Date: May 23, 2023  
To: Planning and Zoning Board  
From: Ellen Hardgrove, City Planning Consultant  
XC: Sandy Riffle, City Clerk  
Brett Sollazzo, Administrative & Permitting Manager  
Drew Smith, City Attorney  
Allen Lane, City Engineering Consultant  
Jim Winter and Galen Pugh, City Landscape Architects  
Re: Landscaping and Parking Variances for 75 Holden Avenue, Boise Cascade

**A variance to allow an exemption to requiring code compliant landscaping when existing development is greater than 5,000 square feet and proposed expansion is in excess of 5,000 square feet.**

**A variance to allow less than the required parking for a warehouse use.**

Exhibit 7 – Homes Adjacent to Property

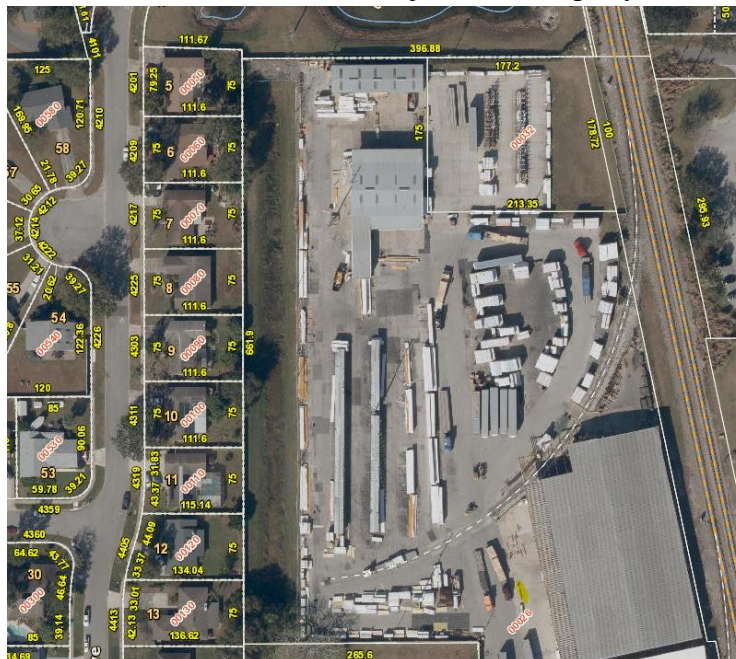
- 2) **Adjacent to the homes along Forestal Avenue** - Trees, although not shade trees, are proposed to be added at a rate of 1 tree/41.25 linear feet on the east side of the stormwater pond that parallels property line shared with the residences along Forestal Avenue. The existing 7 feet high concrete wall is proposed to be maintained.

- a. Maintain the 7 feet high wall along the perimeter of the property adjacent to the church and homes along Forestal Avenue.
- b. Adjacent to the homes fronting Forestal Avenue, on the west side of the existing stormwater pond, provide evergreen shade trees instead of Cypress Trees within the at a rate of 1 tree/35 feet on center, with each tree a minimum of 4 inch caliper and capable of a canopy 30 to 40 feet wide at maturity. Mature height to be attainable within three years. The intent is to provide a dense visual screening from 7 feet to at least 30 feet in height;

Exhibit 9 – Substandard Parking and Onsite Circulation

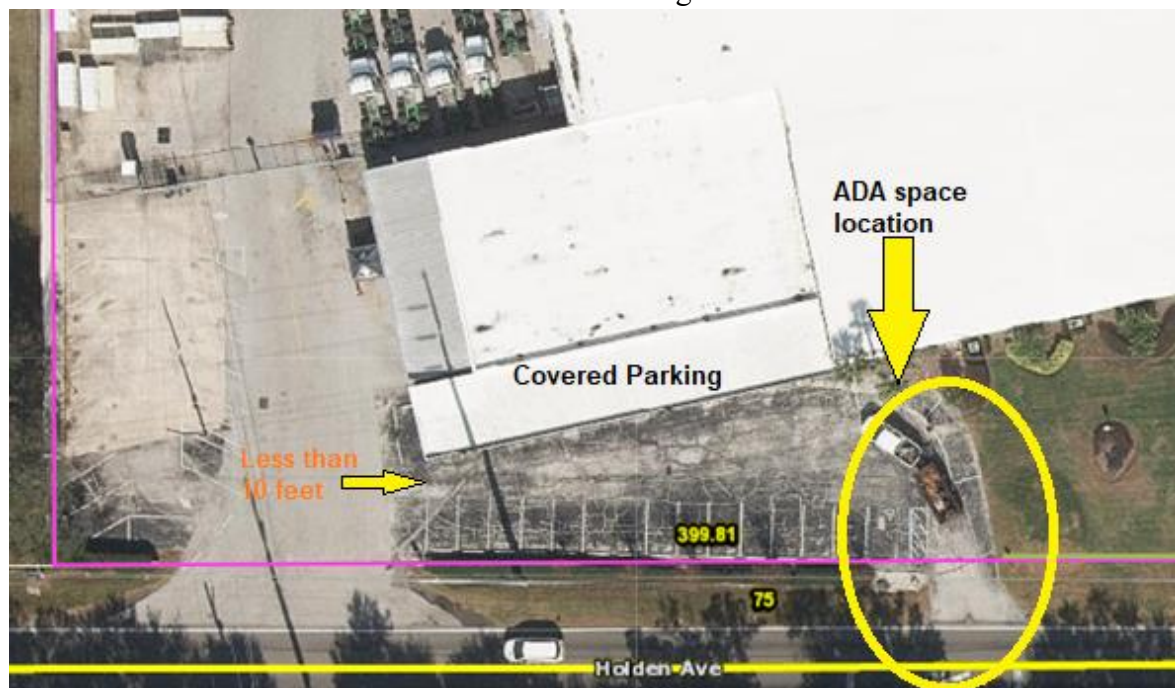
There is concern from a public safety perspective relative to the onsite parking and vehicle circulation such as the narrow width of the drive aisle in the parking lot in front of the building and the location of the ADA compliant parking space as shown in Exhibit 9. It is acknowledged

that conformance with landscaping requirements would further reduce the number of parking onsite; however, the applicant could take corrective by redesigning the onsite parking.

- Provide a minimum 24 feet wide two-way drive aisle or a minimum of 12 feet one-way drive aisle in front of the covered parking (south side of front building), replacing the eliminated parking resulting from the driveway changes in the area east of the easternmost driveway; and,
- If the current ADA space is maintained, provide a landscaped end cap to improve the safety of use this space.
